- Subject** ▶ Change on feeder box complete and box cover complete
- For Models** ▶ 6830, 6831D/DH, 6831DW/DWH, 6831DR and 6832
- Note** ▶ This information applies to European countries and areas only.
- Description** ▶

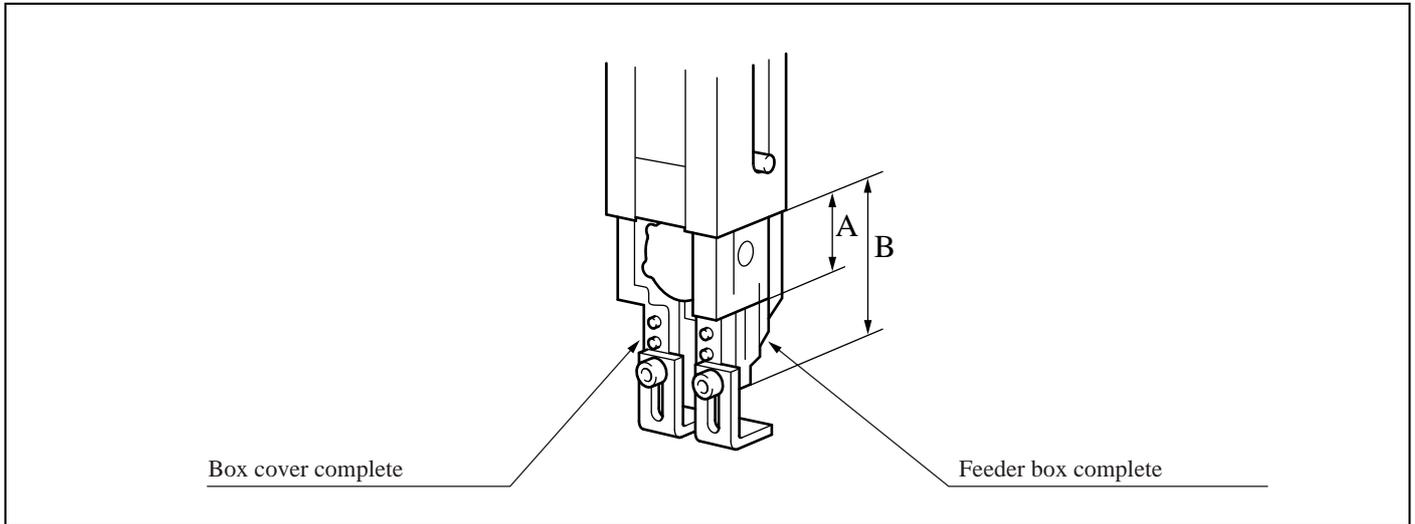
The dimensions (A) and (B) will be changed as follows so that 1-5/8" screws can be fastened.

Dimension	Current	New
A	23 mm (29/32")	24 mm (15/16")
B	46 mm (1-13/16")	47 mm (1-27/32")

Item No.	Current part		Q'ty	I/C	New part		Q'ty	Note
6	Feeder box complete 152467-9		1	No	Feeder box complete 152503-1		1	Interchangeable as a set ↑ ↓
2	Box cover complete 152425-5		1	No	Box cover complete 152502-3		1
